LETTER OF TRANSMITTAL

DATE :	JOB NO. :
May 9, 2014	**23419-013**
ATTENTION : **Mr. Kevin Ture** *KTure@wmschultz.com*	
RE : **Vermont Route 73**	
Rochester, Vermont	
Rochester BRF 0162 (16) Bridge No. 15	
Rochester BRF 0162 (17) Bridge No. 16	
Transmittal #3	**Precast Concrete**

Attached please find our precast framing drawings and individual piece details for the precast/prestressed concrete NEXT Beams, abutment walls, pier caps, wingwalls, and approach slabs, which are resubmitted for approval on the project.

2 AS1 LONGITUDIAL SECTION
1/2" = 1'-0"

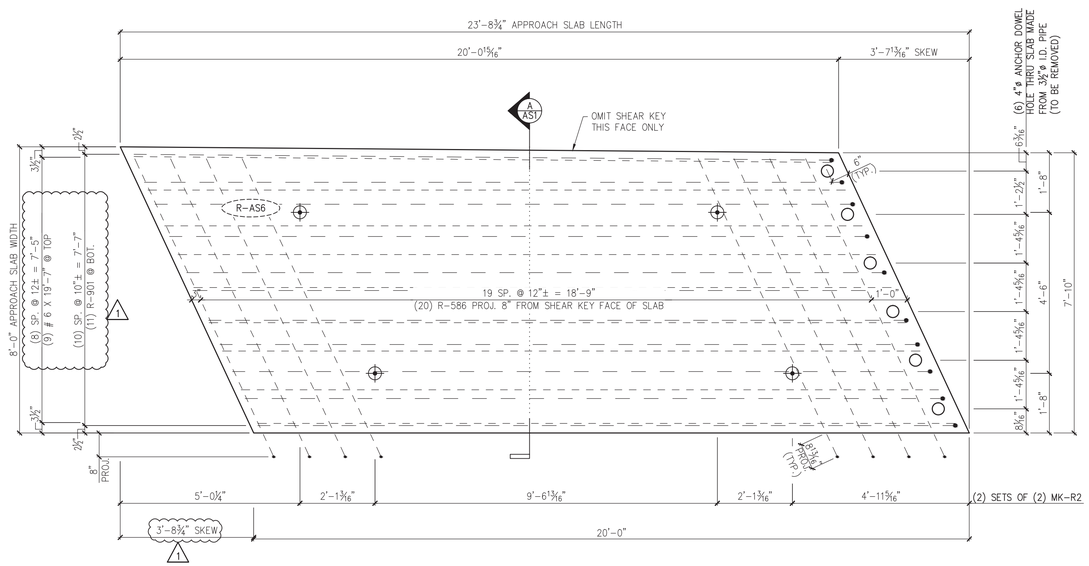
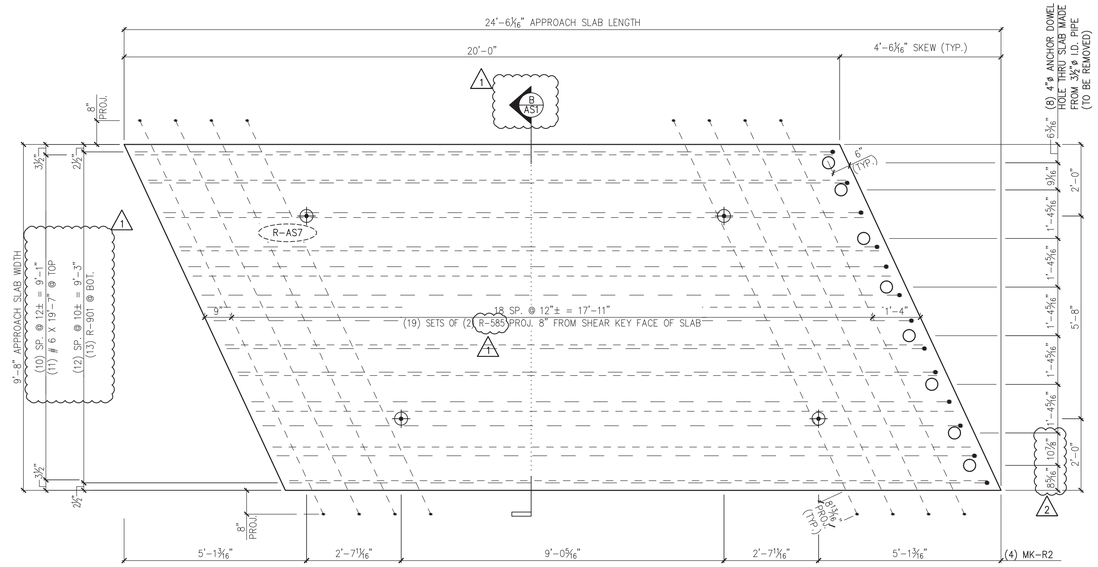
PER THE RFI RESPONSE DATED MAY 8 2014:

FABRICATOR SHALL ROTATE THE #9 BARS TO PROVIDE THE REQUIRED 3" CLEARANCE

2 AS2 LONGITUDIAL SECTION
1/2" = 1'-0"

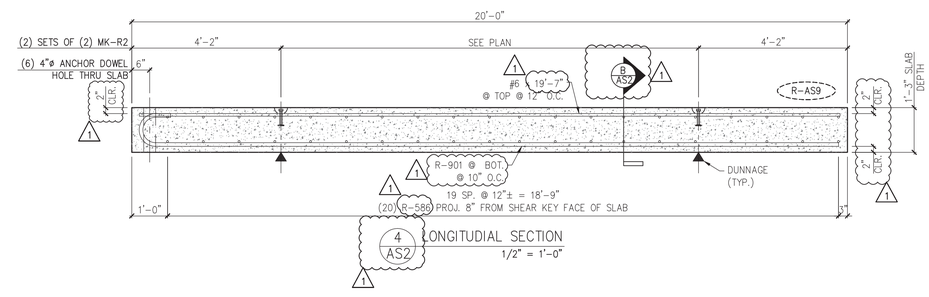
PER THE RFI RESPONSE DATED MAY 8 2014:

FABRICATOR SHALL ROTATE THE #9 BARS TO PROVIDE THE REQUIRED 3" CLEARANCE

1 AS3 PLAN IN VIEW FORM
1/2" =1'-0"

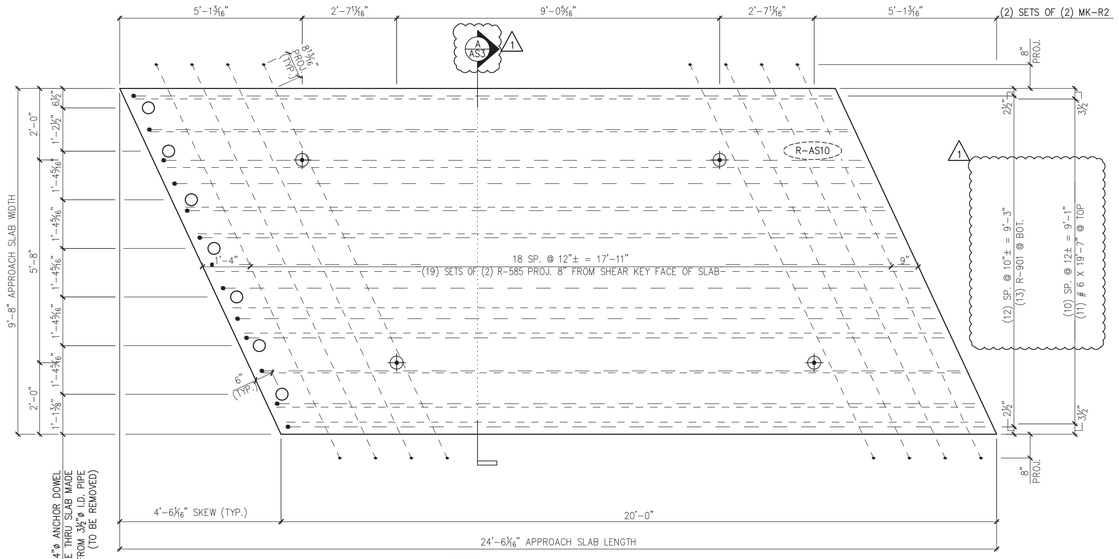
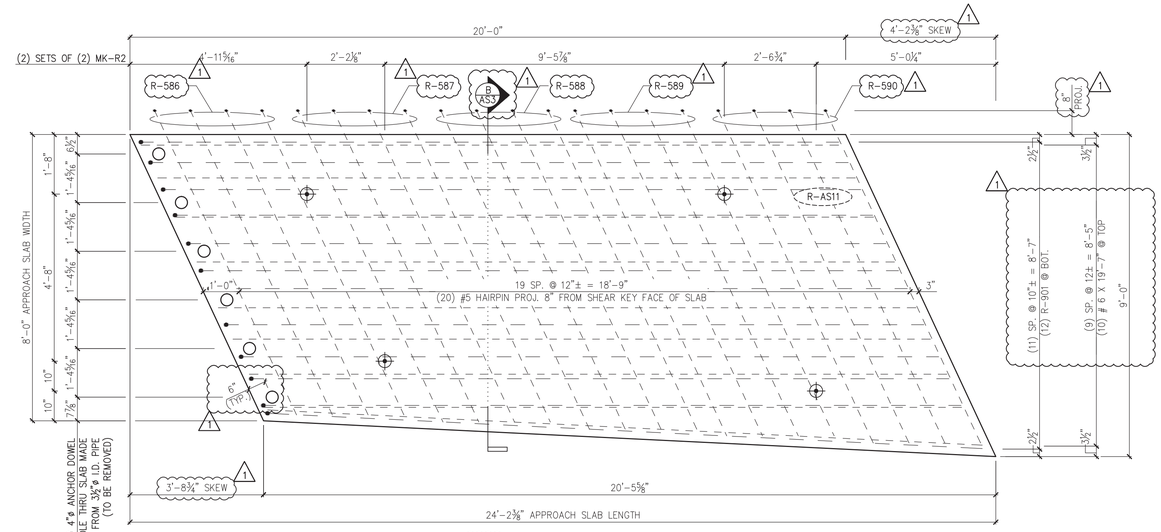
PER THE RFI RESPONSE DATED MAY 8 2014:

FABRICATOR SHALL ROTATE THE #9 BARS TO PROVIDE THE REQUIRED 3" CLEARANCE
